AGENDA
SPECIAL PLAN COMMISSION MEETING
Thursday, November 18, 2021 at 7:00 p.m.
Jackson Municipal Complex
Village Board Room
N168 W19851 Main Street
Jackson, WI 53037

1. Call to Order and Roll Call
2. Concept Plan – Sysco Corporation– W223 N16501 Cedar Parkway (1 Sysco Drive) – Discussion Only
3. Adjourn

STAFF REVIEW COMMENTS
SPECIAL Plan Commission Meeting – November 18, 2021

Agenda Item #2 – Concept Plan – Sysco Corporation– W223 N16501 Cedar Parkway (1 Sysco Drive)

OVERALL DEMOLITION PLAN

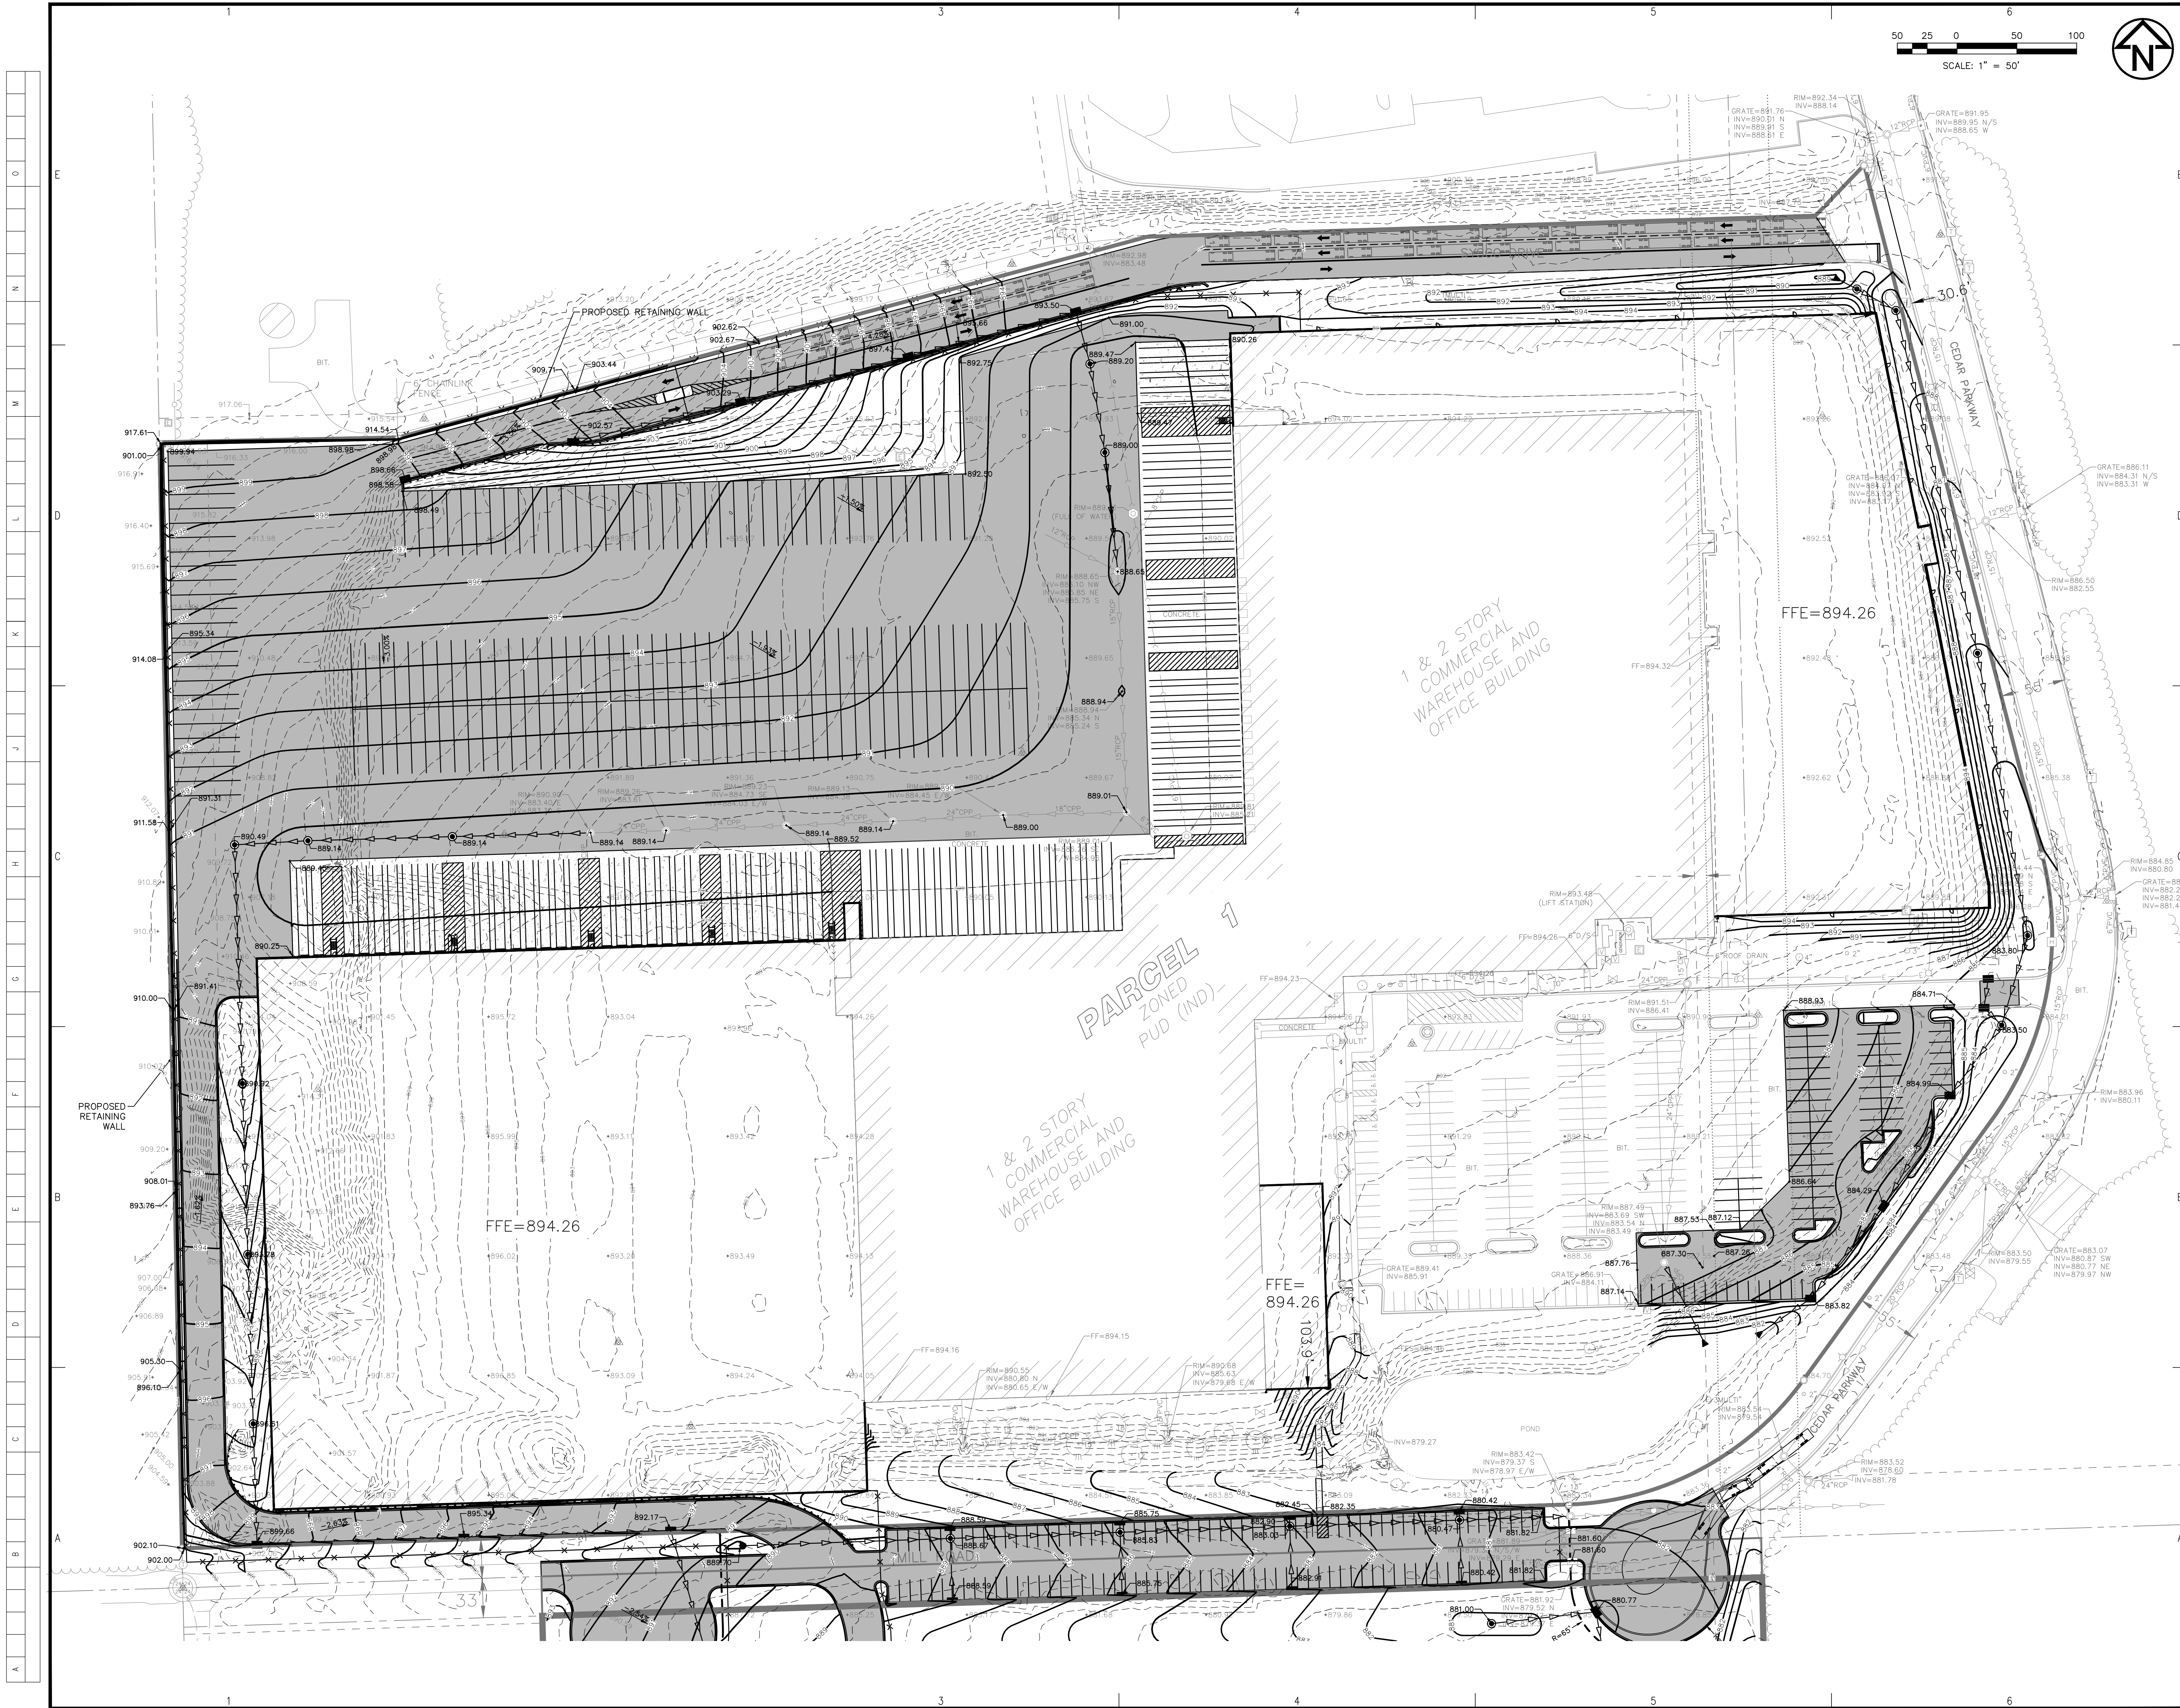
- The submitted plans do not show any form of buffering between the south truck lot and the adjacent residential properties. Buffering is typically required by ordinance.

- It appears, based on the submitted plans, that the parking lot and roadways planned along the west property line will in fact extend to the property line leaving little if any buffer. A retaining wall is planned for the entire length of the west property line. The details of this retaining wall, parking lot, and roadway are not known at this time however, appropriate setbacks are required as well as potential buffers.

- Proposed lighting for south truck parking lot, and how the lights will affect the adjoining properties.
- Is the south truck parking area only used for storage or are the trucks/trailers running 24/7/365-time frame?
- The proposed plan does not have a buffer for the existing single-family residence. Create a buffer by landscaping and berm or move the parking lot to the west side of the property and place the pond on the east side of property providing the buffer.

**OVERALL FLOOR PLAN
COLD AND DRY STORAGE**

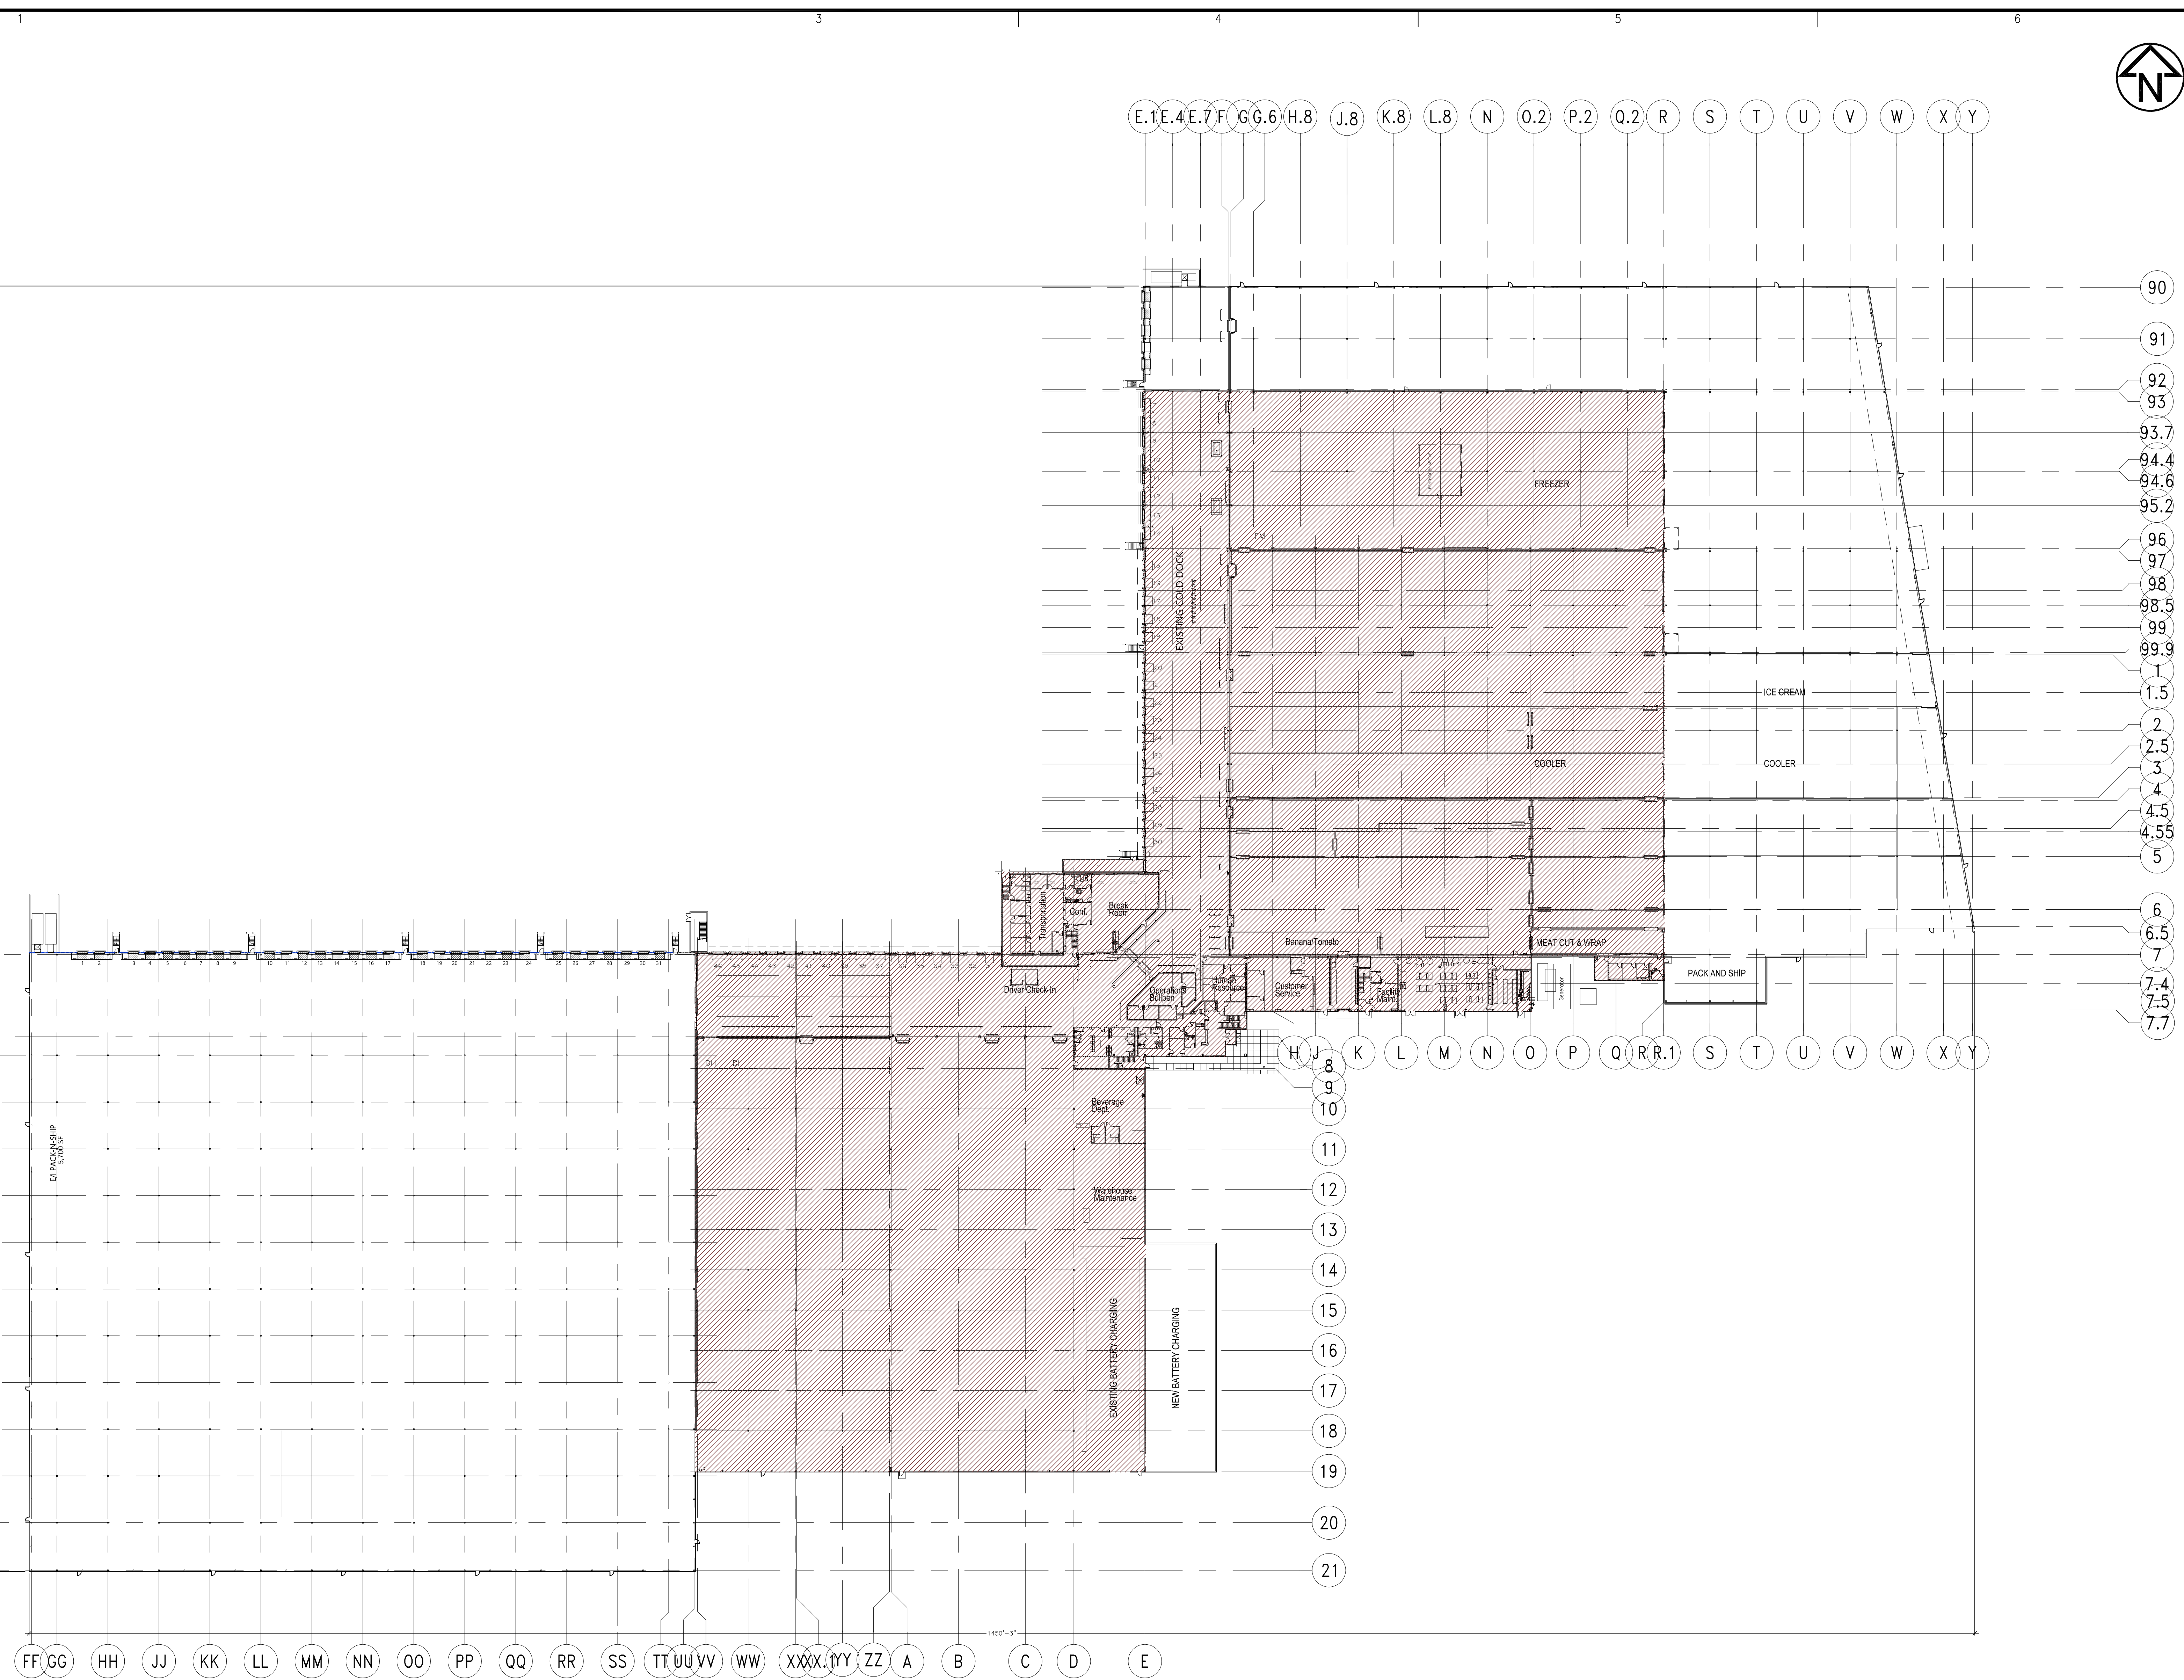
- Existing building height is 33-feet, proposed east and north façades are 39-feet in height along the west side of Cedar Parkway.
- An existing ingress/egress easement is shown along the east property line of the proposed annexed property. It is assumed this is intended to provide access to both the residential lot located adjacent to the northeast corner of the annexed property and the undeveloped parcel located along the southeast corner of the annexed property.

- If the proposed building is allowed to encroach up to the east property line, it is recommended that the building incorporate aesthetic elements that “breakup” large white wall which would be just over 958- feet in total length. Significant landscaping elements should also be incorporated to provide additional “buffering”.
